### **ITEM # 3.0**

#### **PRELIMINARY & FINAL PLAT APPROVAL:**

Retama Phase VI Subdivision (Private)  
9.173 acres being out of Lot 14,  
Del Monte Irrigation Co. Subdivision  
PUD (R-1)  
Developer: Rhodes Development, Inc.  
Engineer: Melden & Hunt, Inc.

**Re: RETAMA VILLAGE PHASE VI SUBDIVISION – Variance Request**

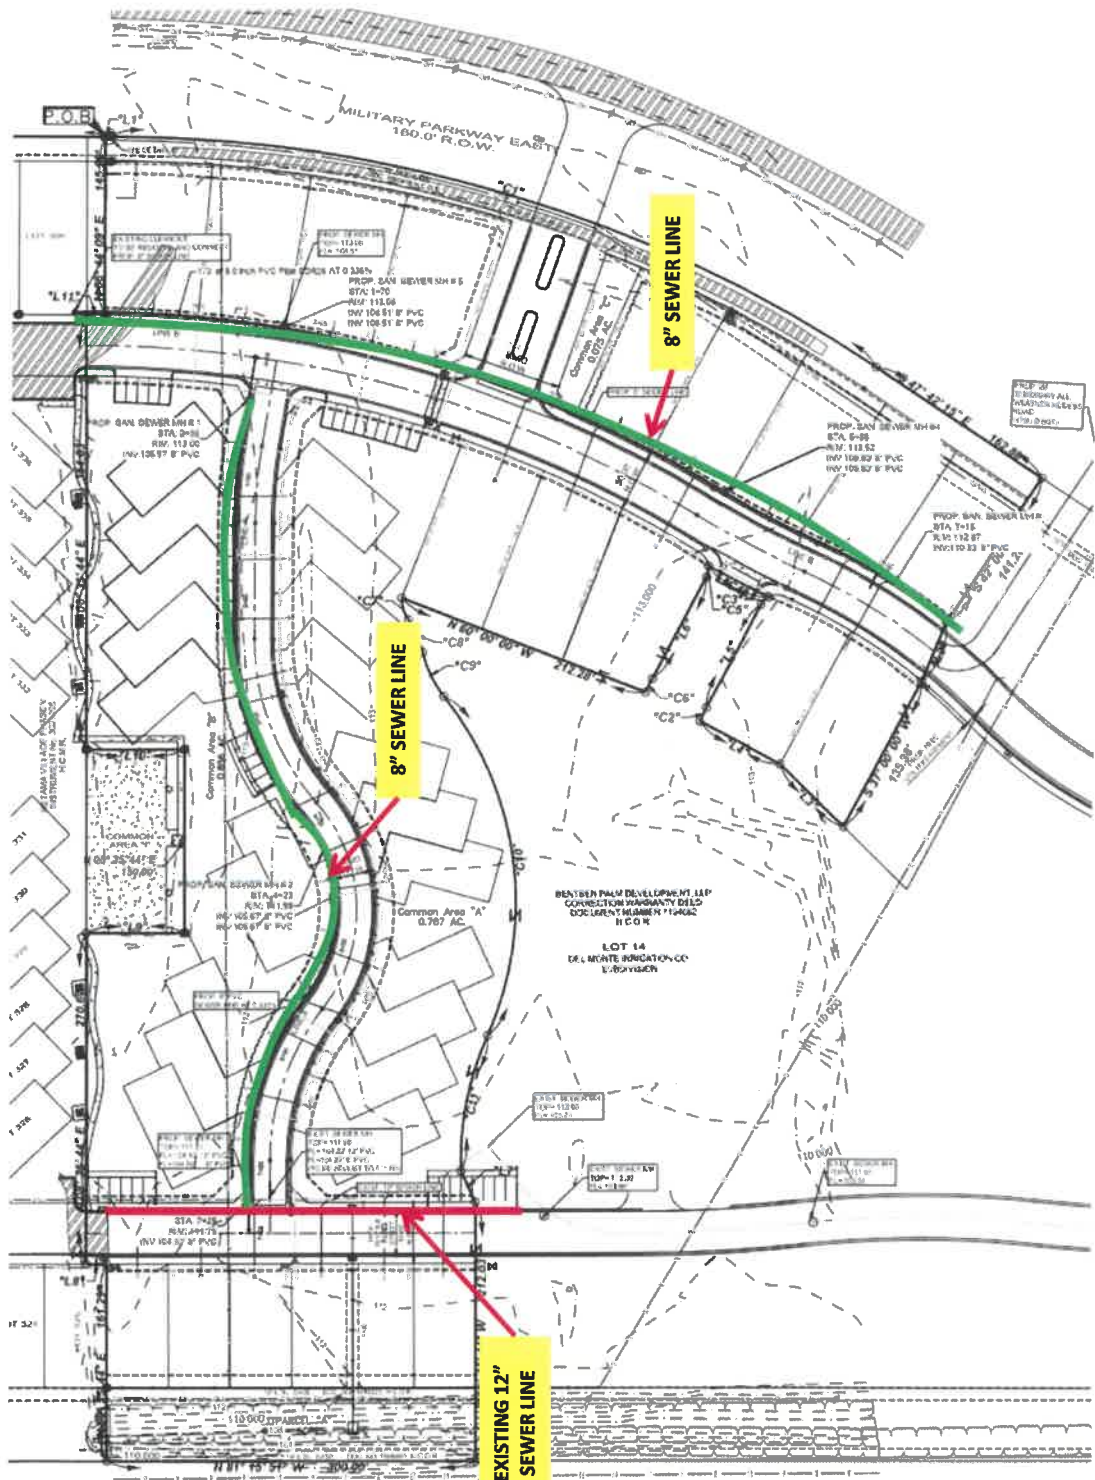
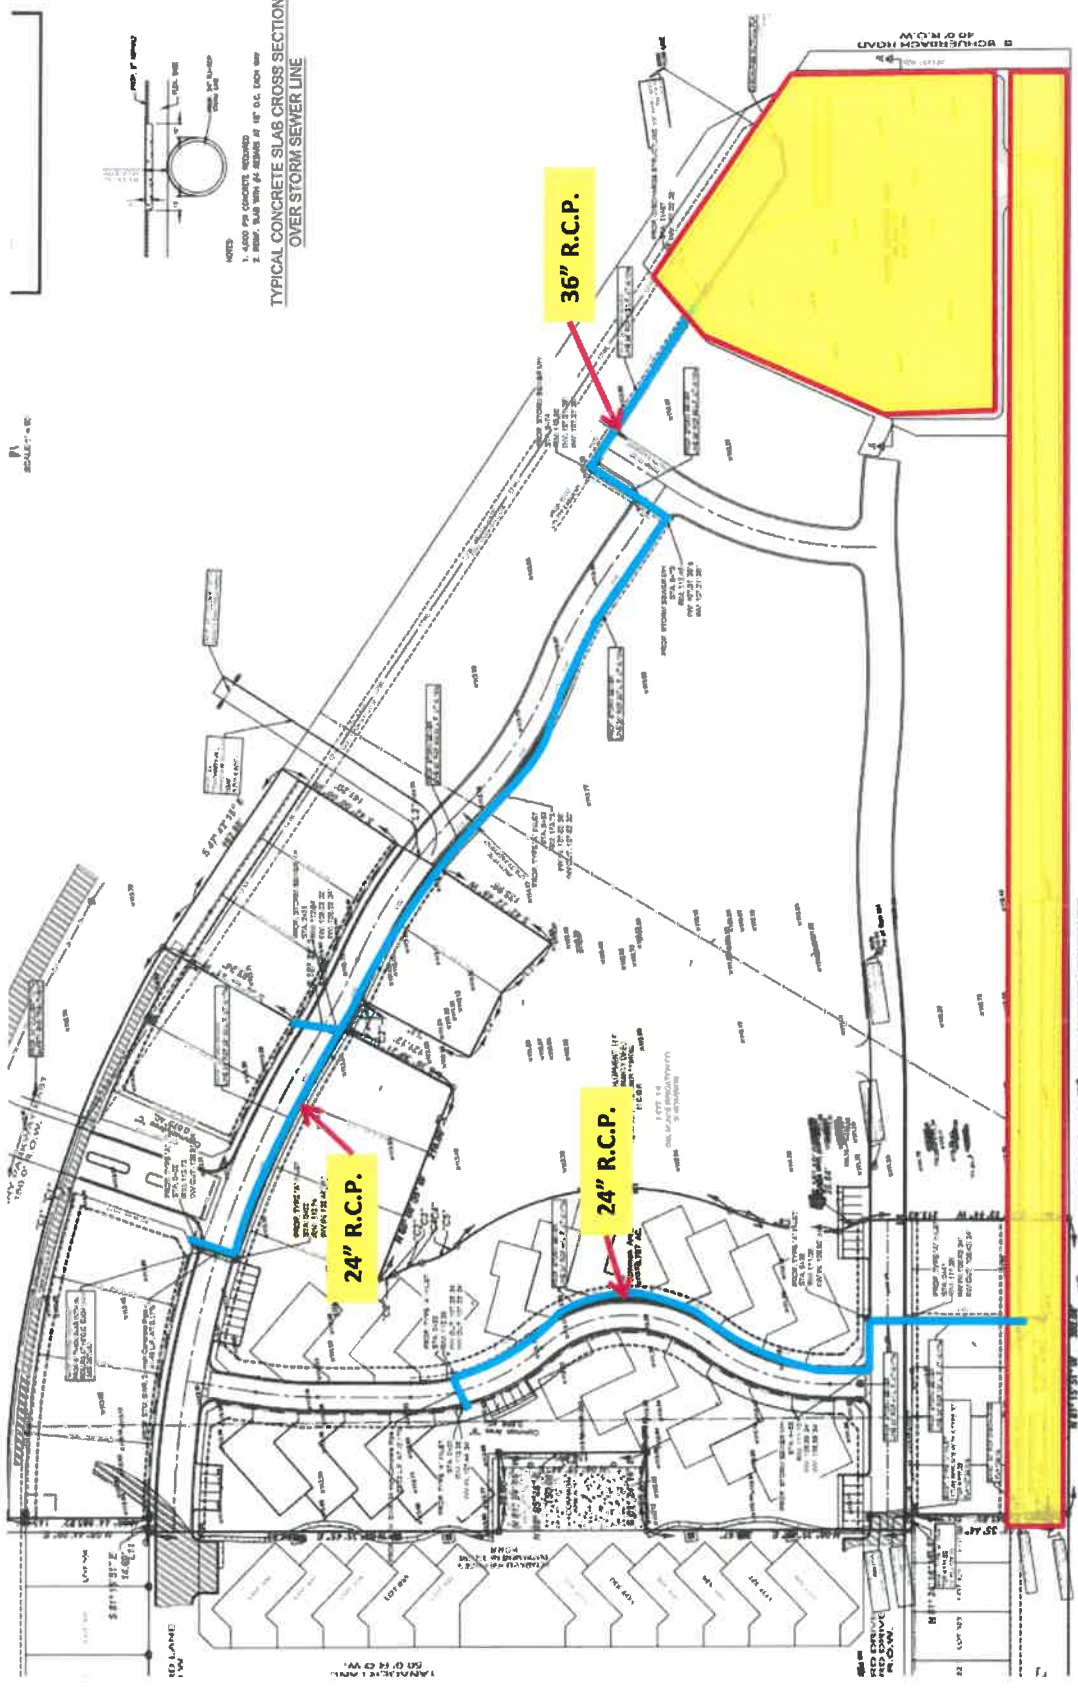
NOTES:  
 1. SEE ALL CONCRETE REVISIONS  
 2. SHOW SLAB WITH 6" REBAR AT 18" O.C. EACH WAY  
 TYPICAL CONCRETE SLAB CROSS SECTION  
 OVER STORM SEWER LINE
